14 February 2025

ADDENDUM NO. 3

RE: Chisholm Creek Utility Authority  
Wastewater Treatment Facility Improvements  
WCI File: 20-600-514-00

SHEET NO:  
**G-021**

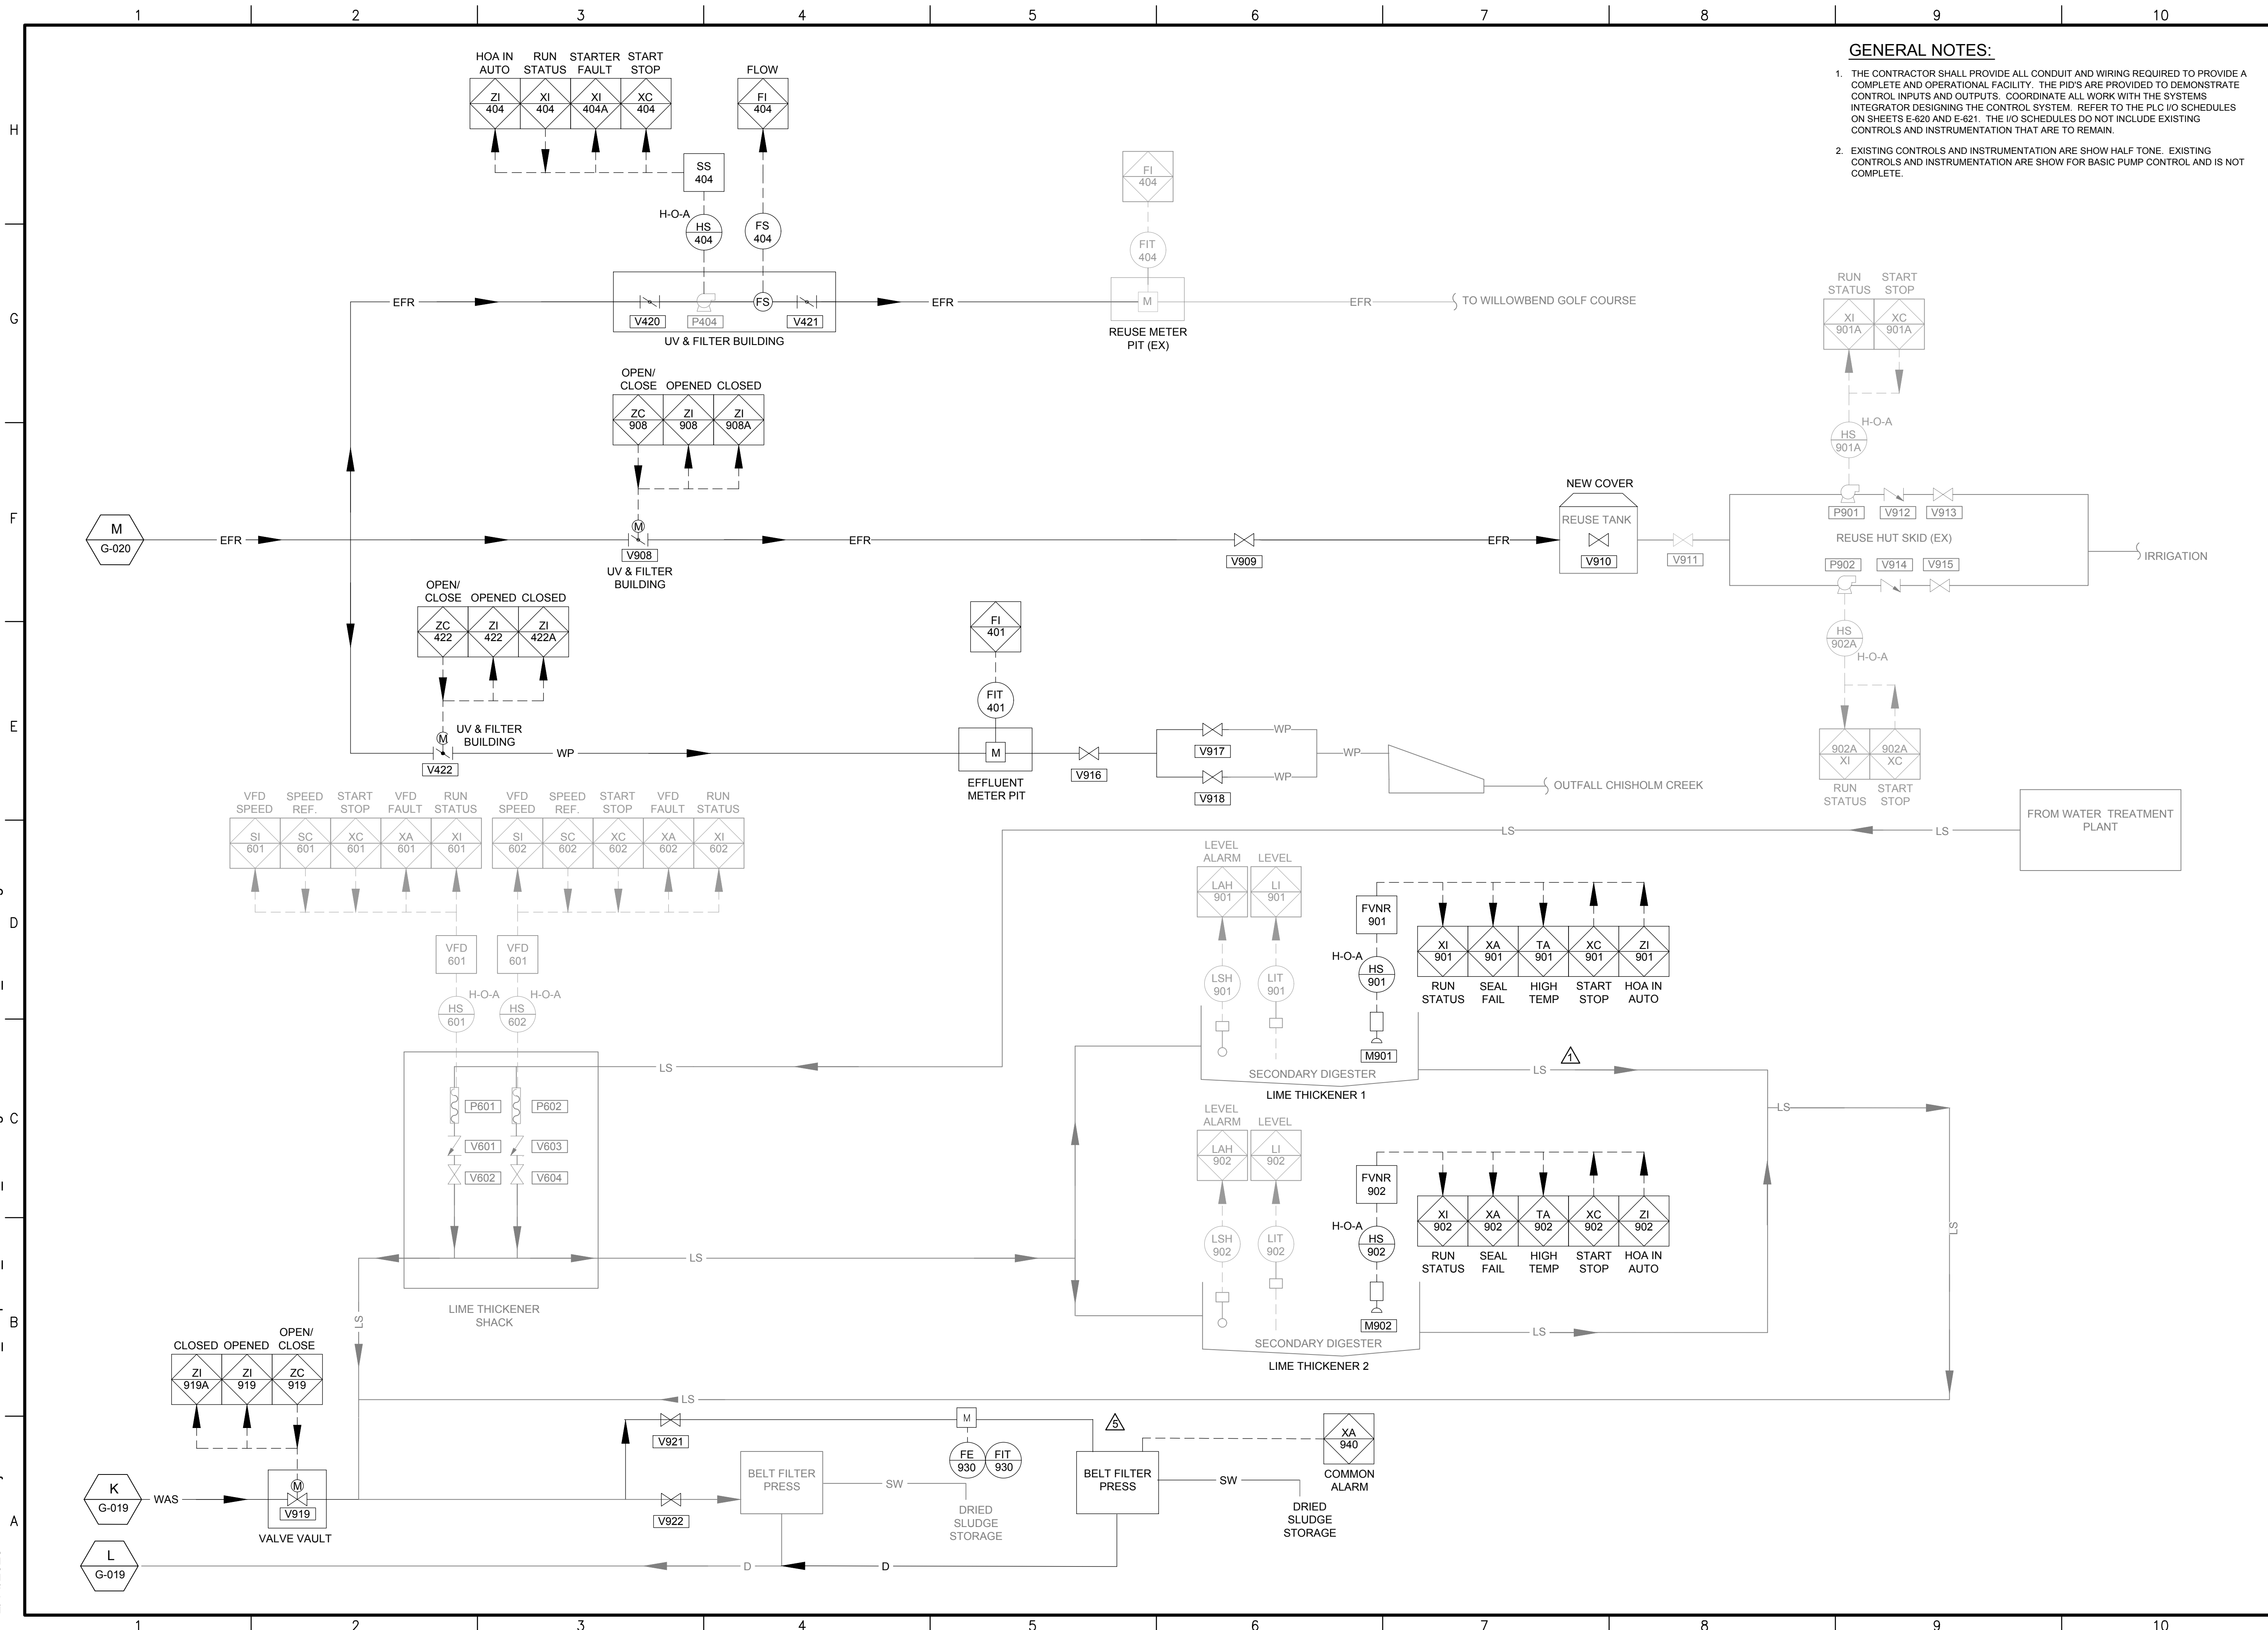
12. Sheet No. G-021  
ADDITION of Belt Filter Press common alarm signal XA-940.  
MODIFIED flow meter location and flow signal to the Belt Filter Press. Also, assigned I/O tag numbers to the flow meter.  
MODIFIED the Reuse Meter Pit flow meter to be shown as “bold” for new equipment.

**E-002**

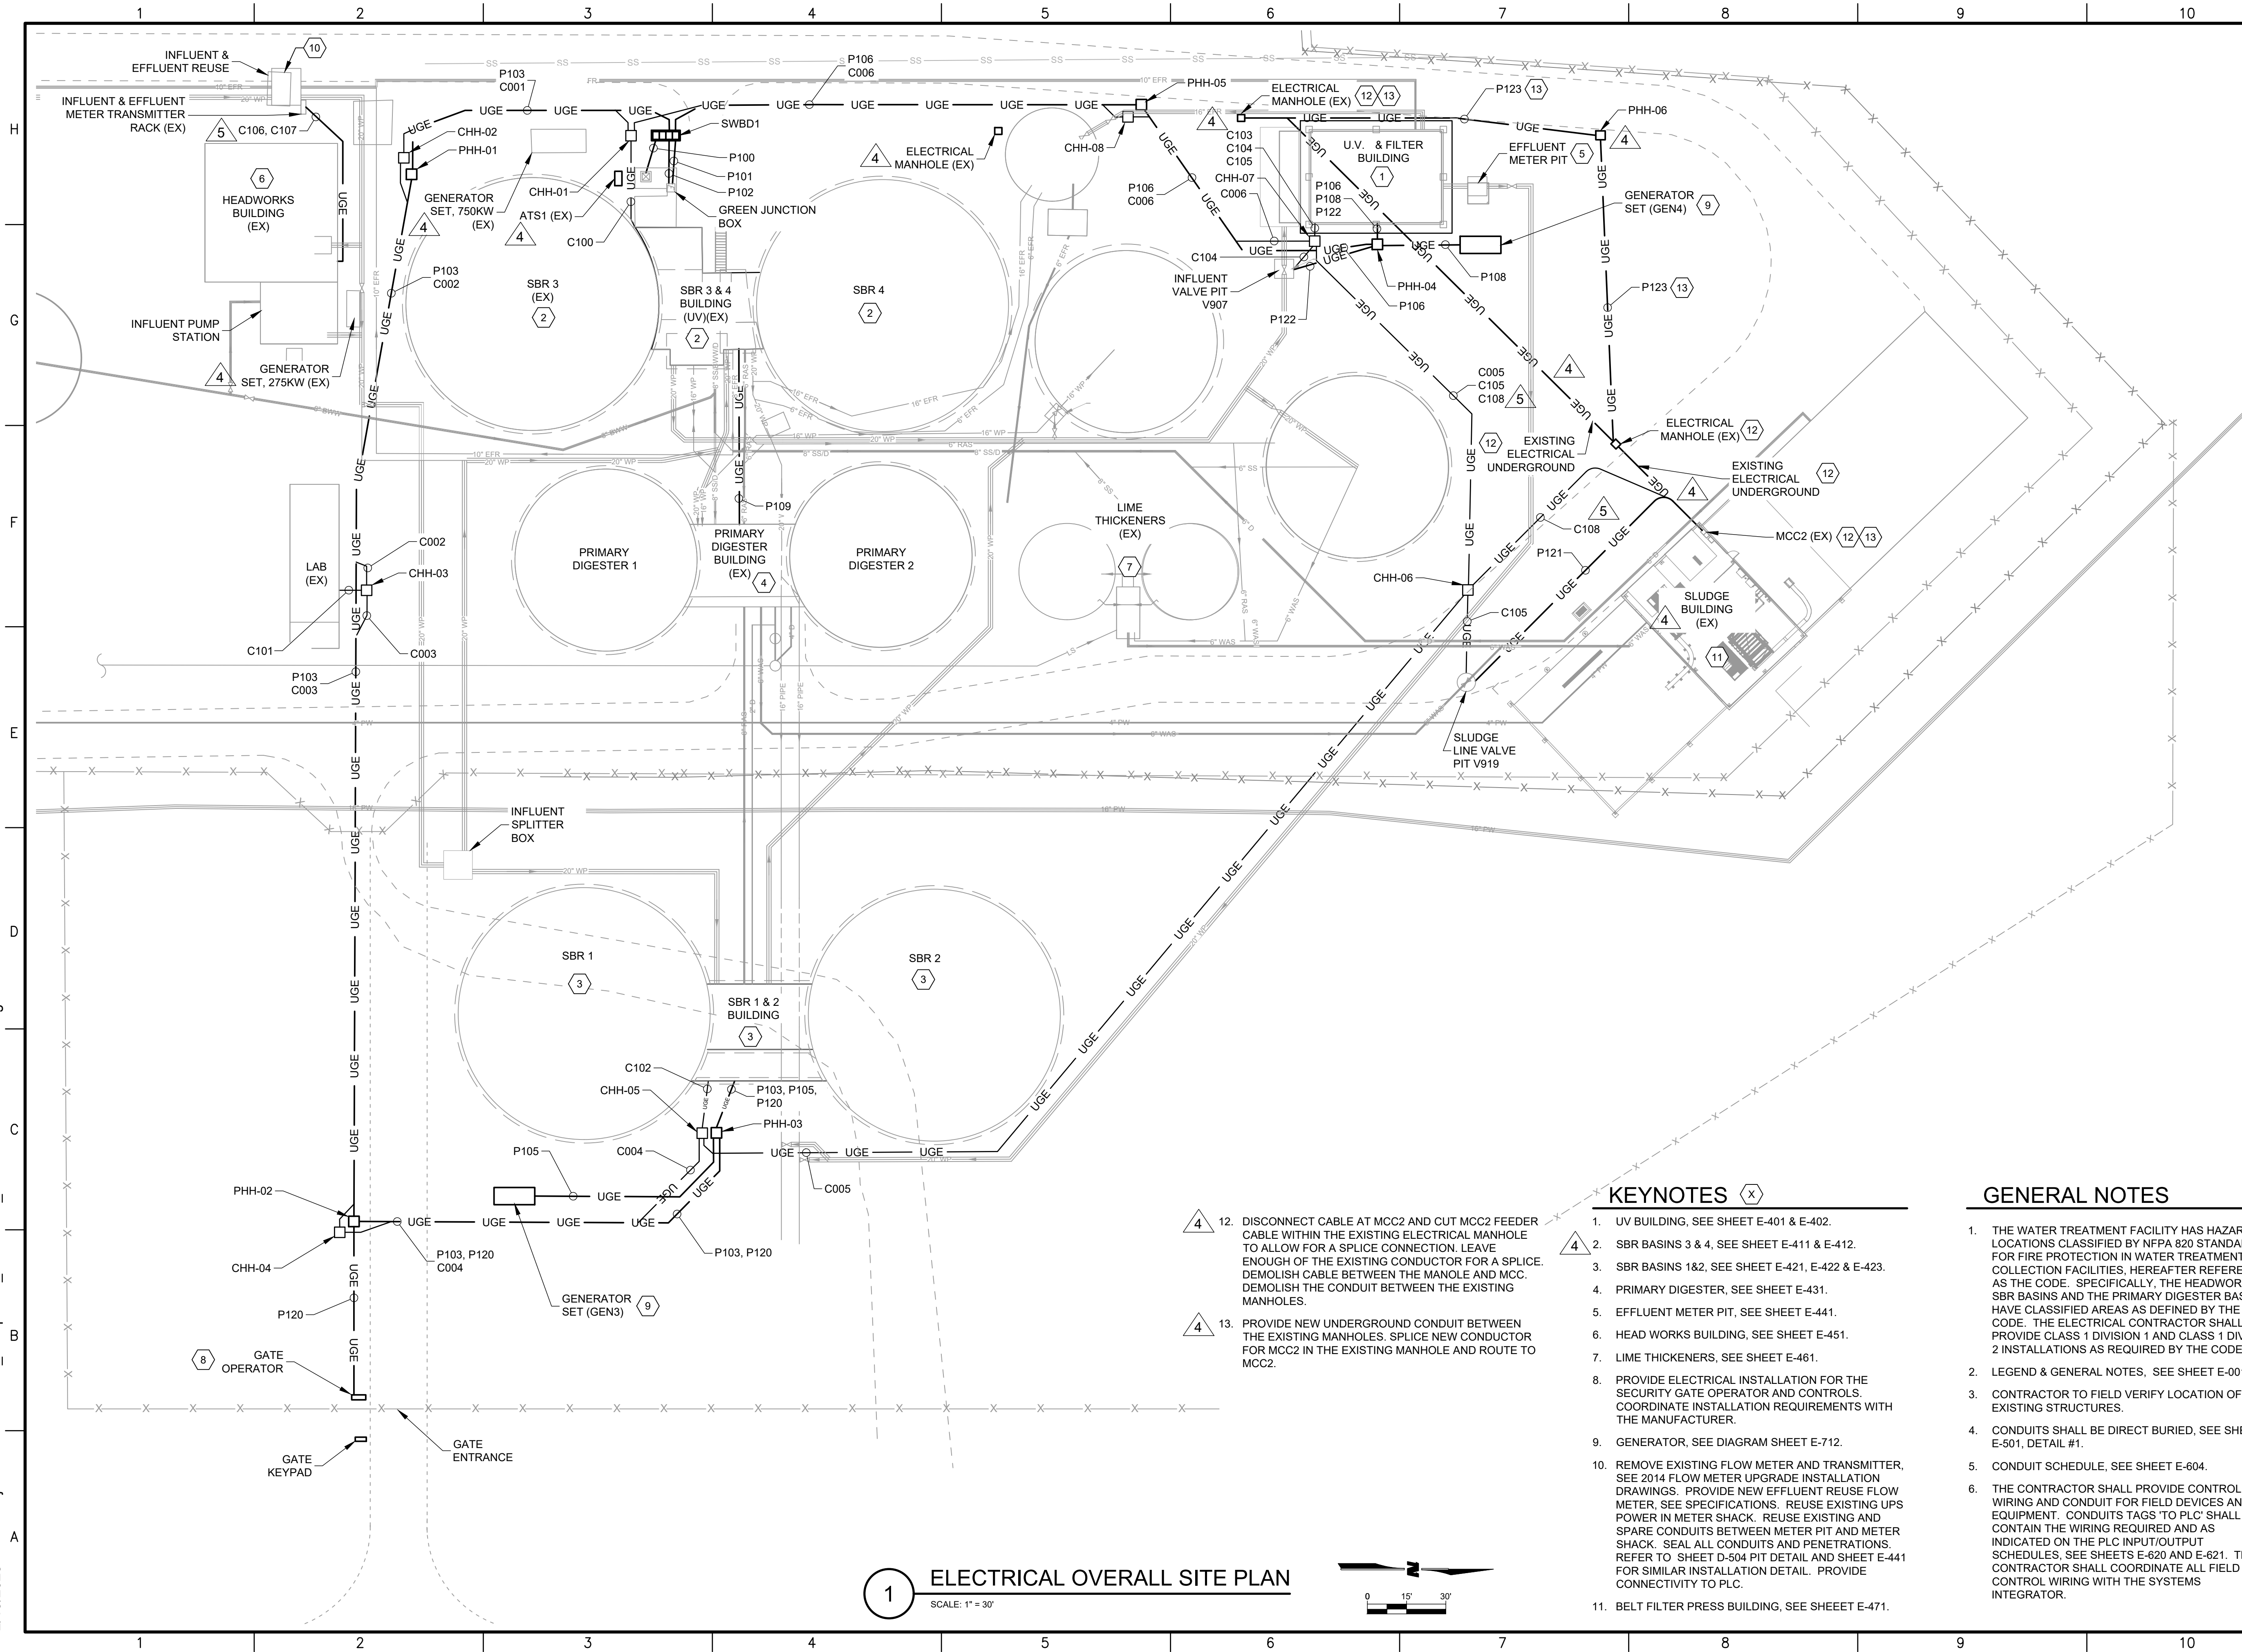
13. Sheet No. E-002  
ADDITION of conduits C106, C107, and C108.
14. Sheet No. E-401  
ADDITION of conduit C108.
15. Sheet No. E-431  
MODIFIED the “Aerator 2 (Floating)” disconnect to show 100A/3P.

SHEET NO:  
**E-451**

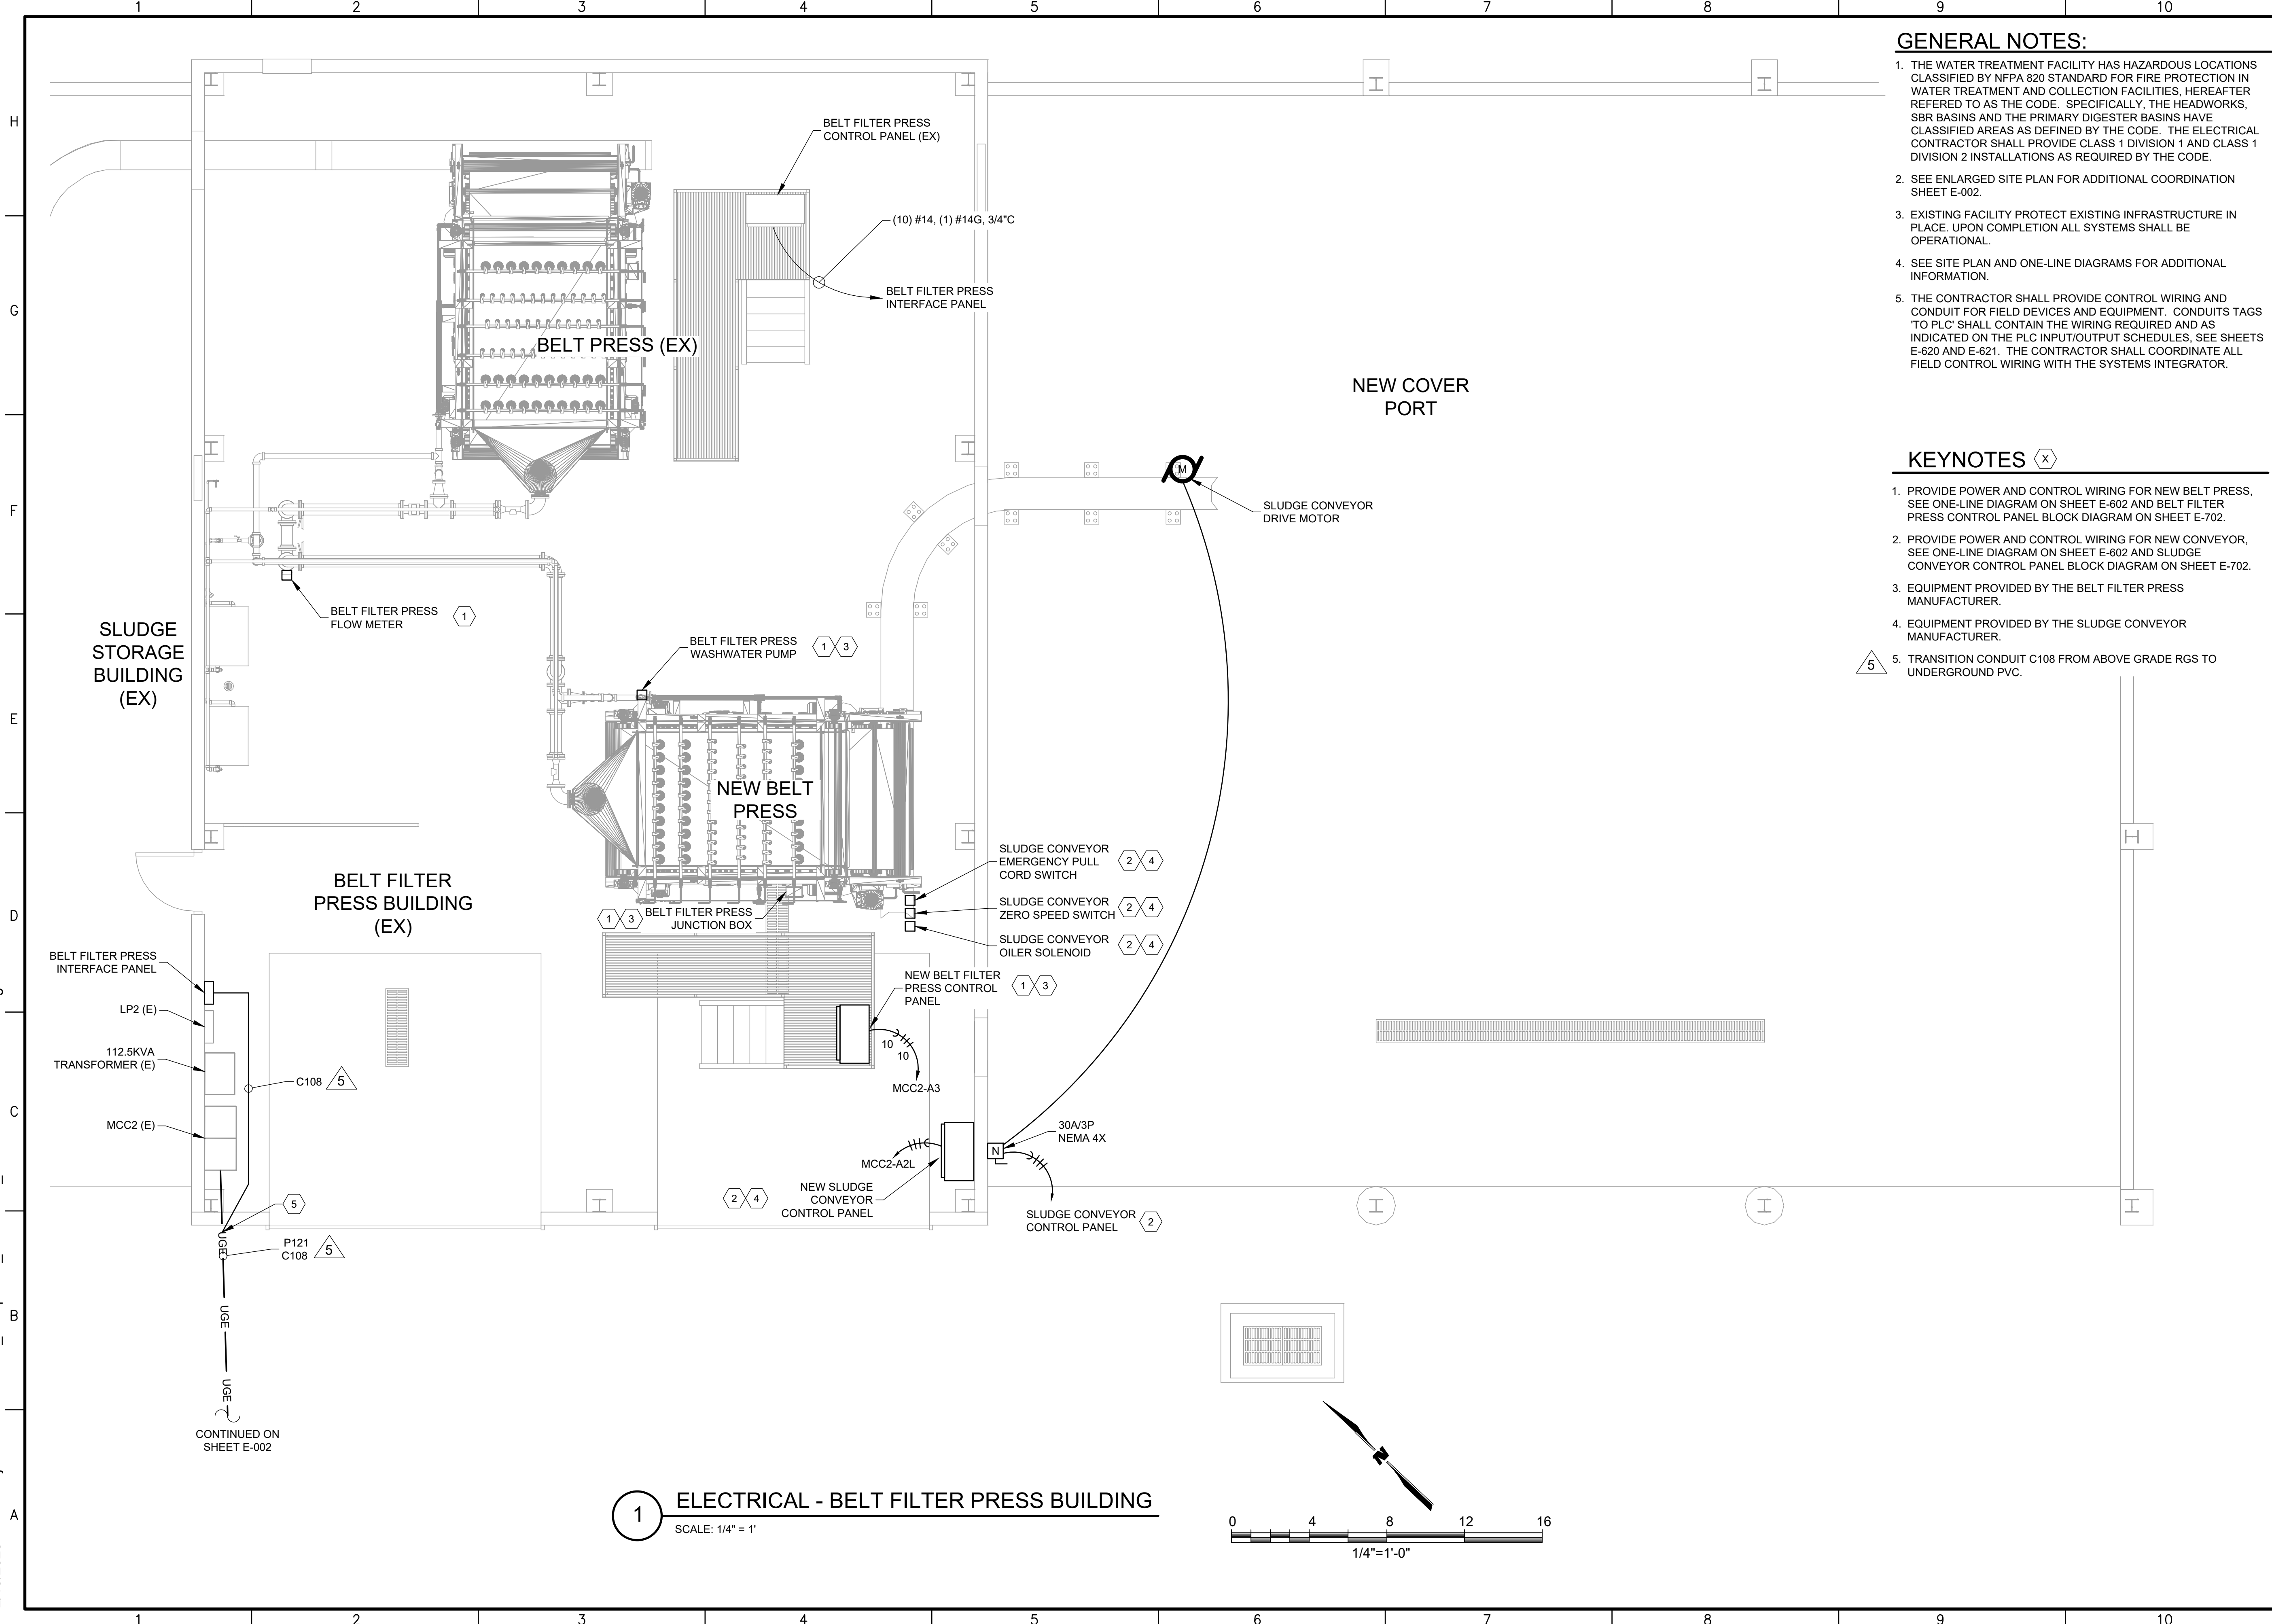
16. Sheet No. E-451  
ADDITION of North arrow.  
ADDITION of conduits C106 and C107.  
ADDITION of Keyed Note 7.
17. Sheet No. E-471  
ADDITION of conduit C108.  
ADDITION of Keyed Note 5.

7. SEE SHEET E-002 FOR CONTINUATION OUTSIDE OF THE BUILDING.
